Delivered by email to [iaac.springbank.aeic@canada.ca](mailto:iaac.springbank.aeic@canada.ca)  
Impact Assessment Agency of Canada (IAAC/CEAA)  
Attention: Jennifer Howe (IAAC / CEAA)

Re: Sediment & Air Quality

### Summary of Findings:

## Appendix 1: Sediment Map (GoA Website 2018-05)

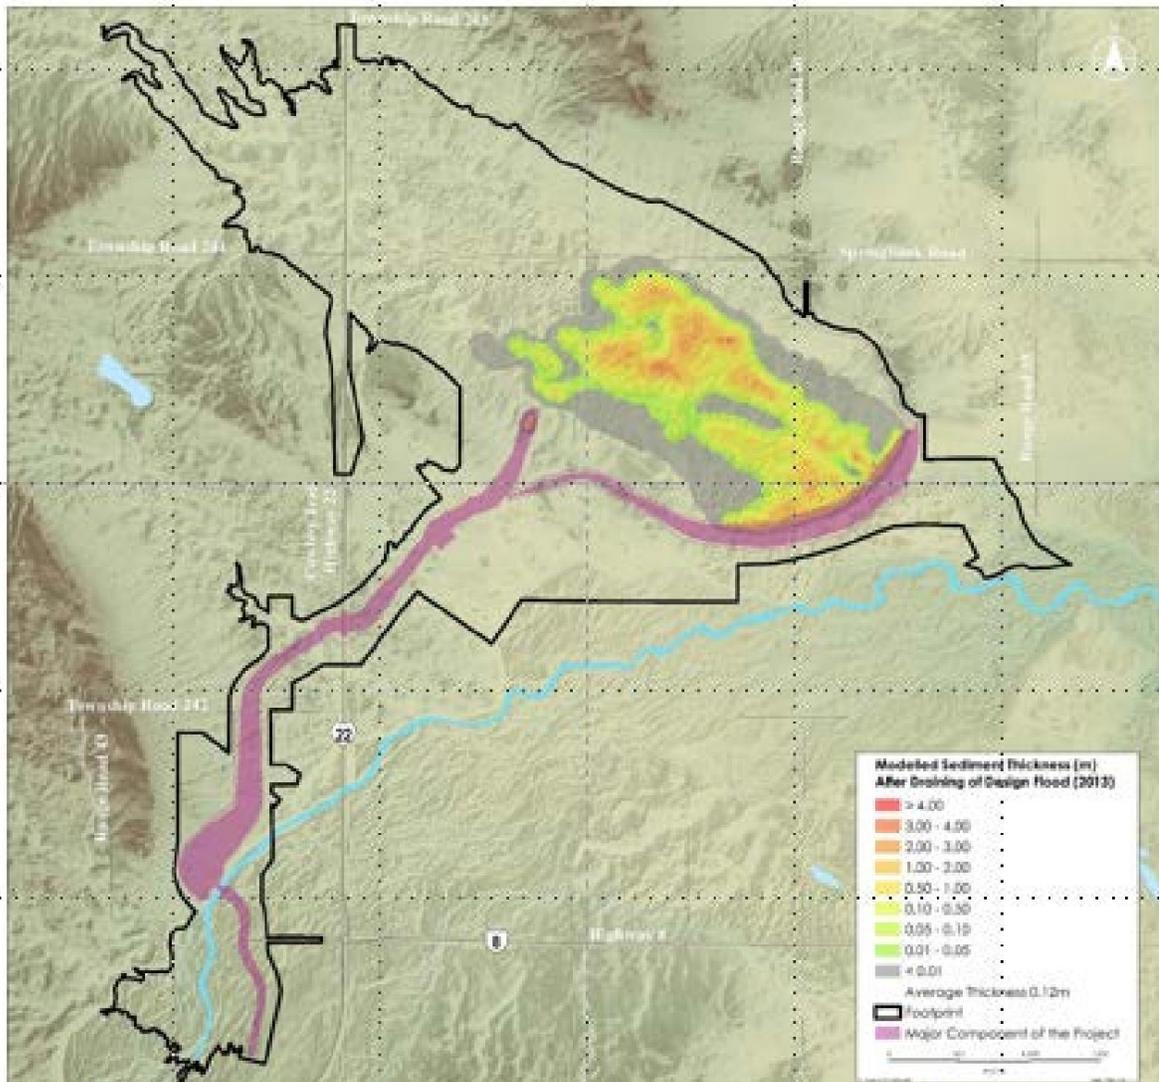
What are the impacts of this **additional 530 to 570 acres of sediment accumulation >10cm**? How does this impact plants, traditional uses, biodiversity? How does this impact the cost of reclamation post-flood? How does this impact the post-flood environment? In Ex 324, pdf page 17, the Proponent states “Desired cover is expected within one to two growing seasons following flood events for non-native areas and within three growing seasons for native areas. Potentially more than 10 years may be required for conditions to resemble baseline conditions.” There will not be 10 years between floods!

The various sediment maps provided by the Proponent are problematic and consistency over time is lacking. The most recent sediment map, Exhibit 327, pg 196, shows sediment deposition which varies greatly from Exhibit 218, page 85 (both show a late release flood). In Exhibit 327, the range is from 0-3cm, 3-10cm and 10-100cm? Whereas, in Exhibit 218, this is 0-3cm, 3-20cm and 20-100cm. This makes it difficult to assess the changes. Additionally, a range of 10cm-100cm or 20cm-100cm is too wide fully understand the sediment impacts. Further, Ex 218 shows the underlying topography, including water bodies, while Ex 327 does not.

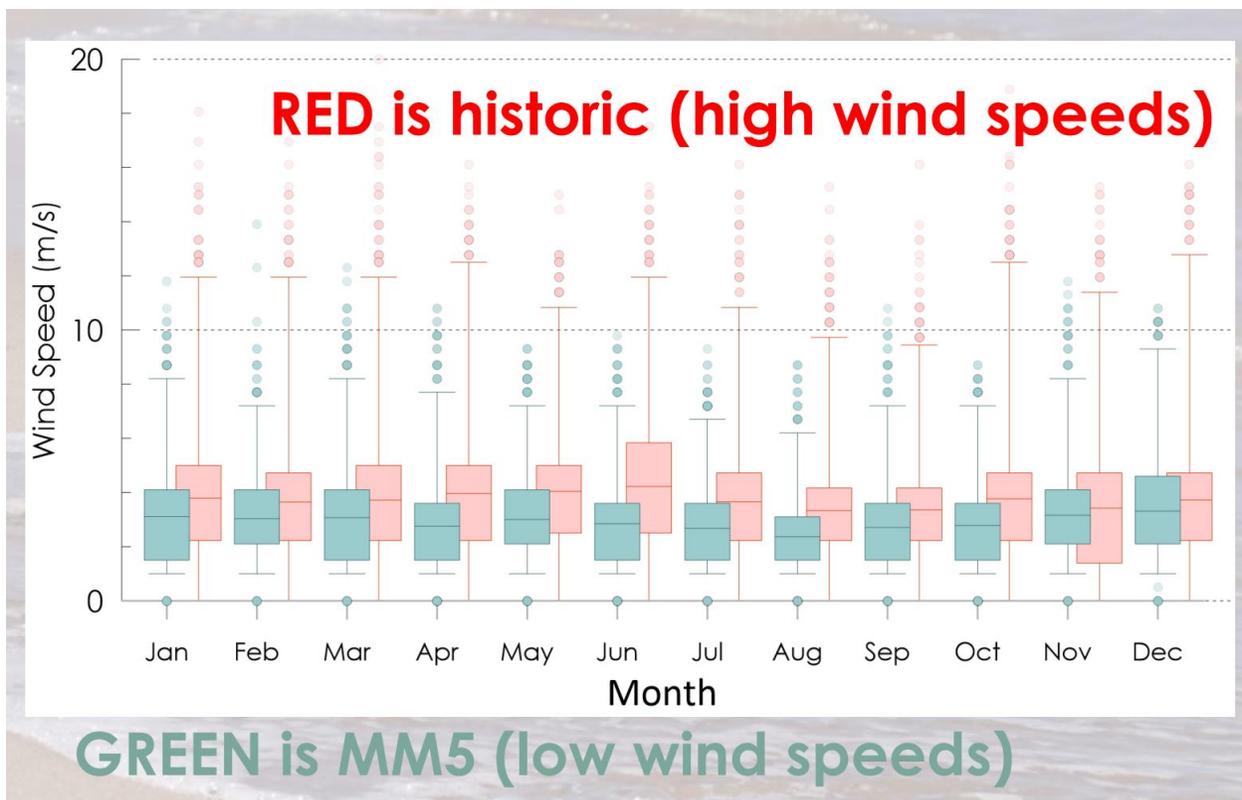
**From Dr Zelt's presentation (Ex 401), the following illustration shows the higher wind speeds in Springbank (red) that were not contemplated by the Proponent:**

**The Proponent's air emissions model cannot be allowed to stand as the basis for the human health conclusion by IAAC or the Proponent.**

Figure A6: 1 hr 99.9<sup>th</sup> PM2.5 1:200yr

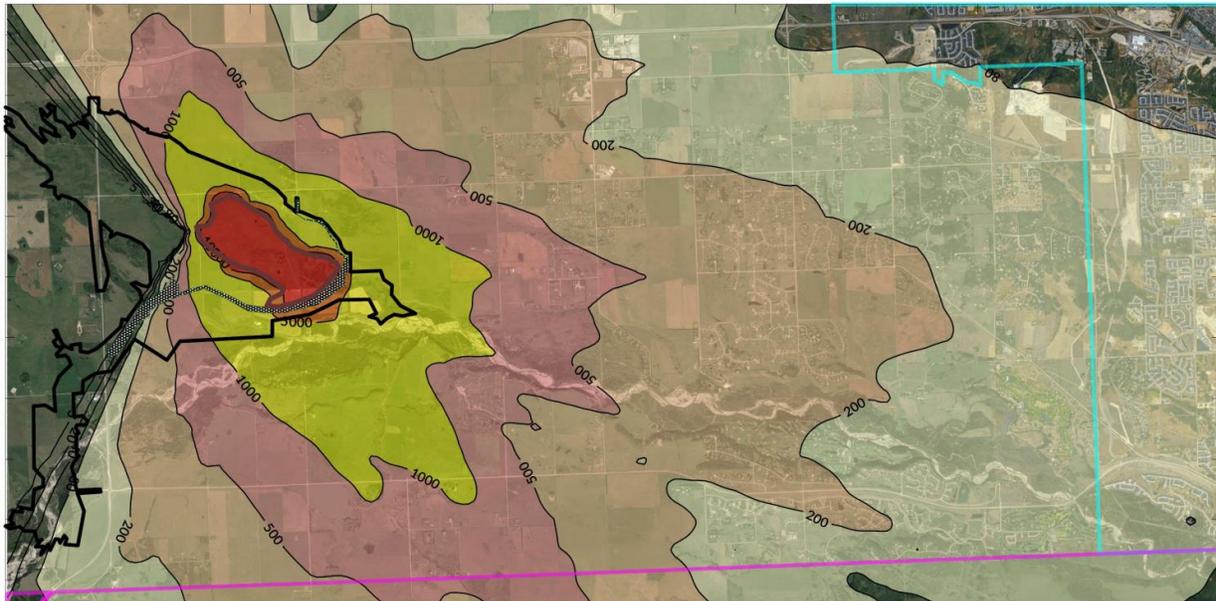
Dr Zelt's presentation, Ex 414, shows the PM2.5 particulates in an unmitigated design flood, below. It is clear that this is a huge human health issue that extends well into the City of Calgary's western edge and Tsuut'ina Nation.

- 2. Potential Impacts
  - What they didn't show you
  - **Same Assessment but NO CONTROLS**

## Air Quality Map: AT PM10 Max 24-hour 1:200 Flood (A4-17)

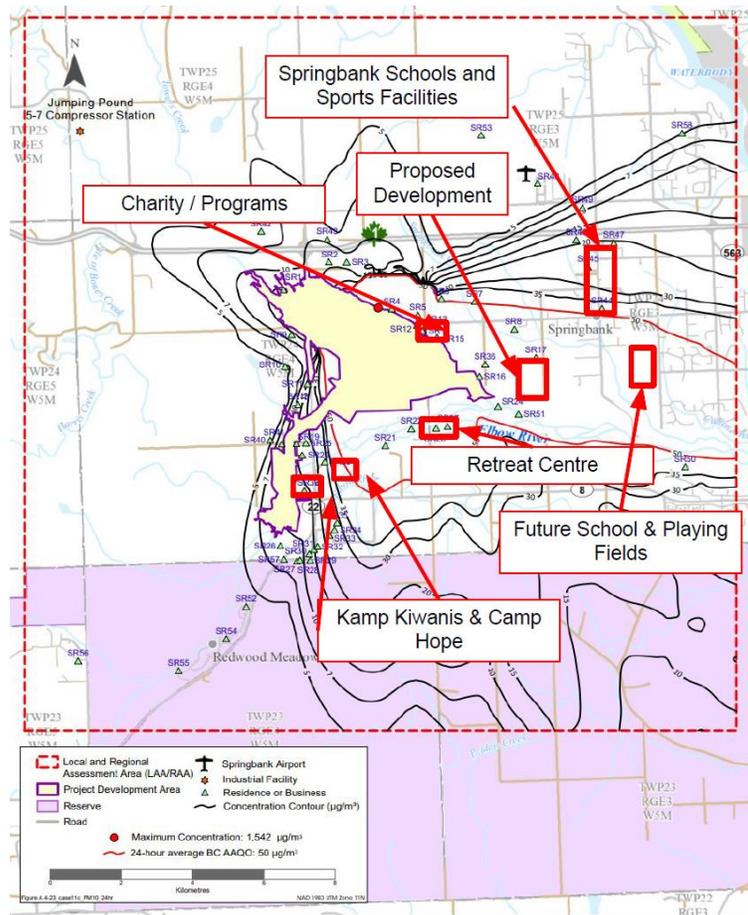
ask IAAC to use new information to update its human health conclusions. Further we ask IAAC to consider the broader implications of the sediment-related emissions and the risk to the operations of service providers such as Calaway Park and the Springbank Airport. We ask IAAC to note that camps for kids are in high-risk air emissions locations, while our schools and the bulk of homes in central Springbank are just east of SR1. From NRCB Exhibit 398, using the Proponents PM10 forecast (note that the Proponent does not want to monitor PM10, which we disagree with):
